Serial No. NA3-08-064R  
Docket No. 52-017  
COL/GY

**DOMINION VIRGINIA POWER**  
**NORTH ANNA UNIT 3 COMBINED LICENSE APPLICATION**  
**RESPONSE TO REQUEST FOR ADDITIONAL INFORMATION LETTER 012**

**Response to NRC RAI Letter 012**

**Figure 14AA-201 Preoperational and Startup Test Organization (Typical)**

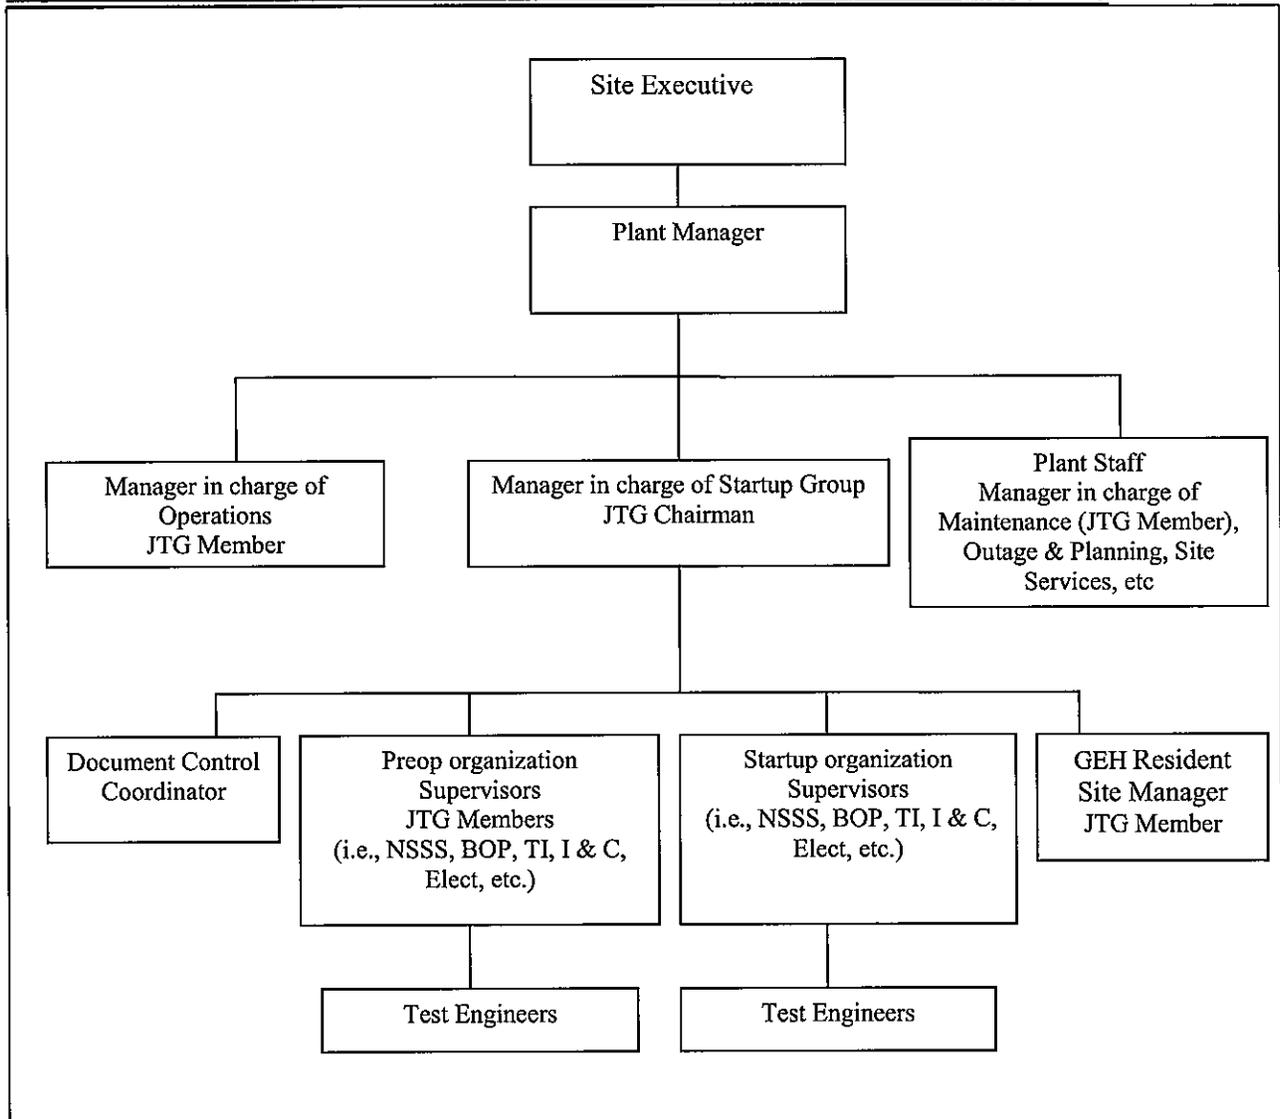
**Dominion Response**

FSAR Chapter 14 will be revised as indicated in the attached markup.

The Startup Test Group consists of Startup Testing Supervisors who report to the manager in charge of the Startup Group. Startup Test Engineers are assigned to this group and report directly to one of the Startup Testing Supervisors. Qualifications of Startup Testing Supervisors and Startup Test Engineers are set forth in Table 13.1-201. Figure 14AA-201 illustrates the organizational structure of the Startup Group.
